RE: Technical Review Responses for Partial Bond Release 3 for Permit NAFK-9601

Falkirk submits the following responses to the technical review items noted in your August 17, 2009 letter for the above-referenced bond release.

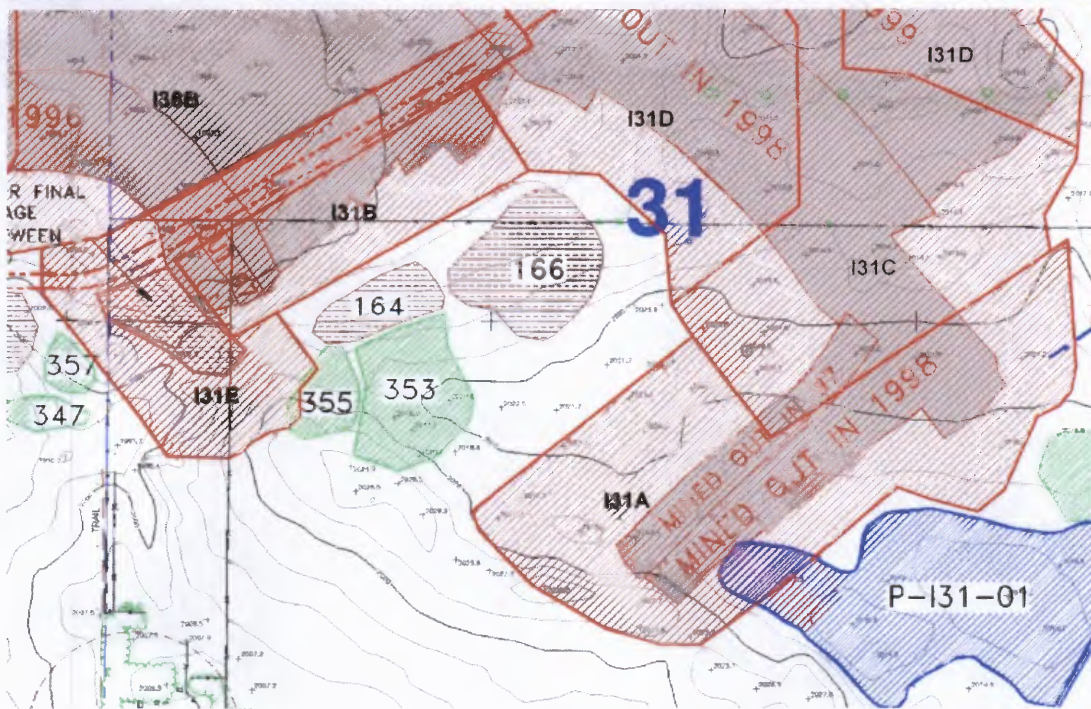
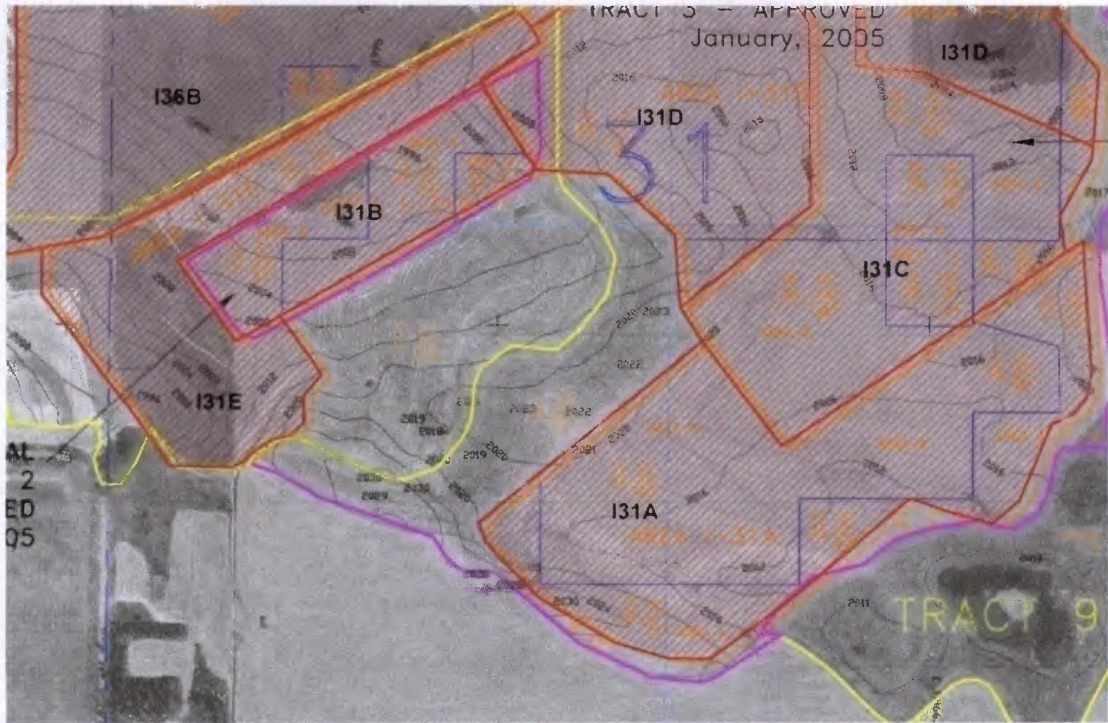
- c) Please illustrate and label the 2.77 acre parcel of reclaimed prime farmland in the SE¹/₄ of Section 36 as described in Section 2.8.1 - Soils and Prime Farmland Narrative and shown on Section 4.1.2 - Post-Mining Land Use Map of the permit.**

Please see updated Attachment VII, Regraded Spoil Contour and SPGM Respread Thickness Map.
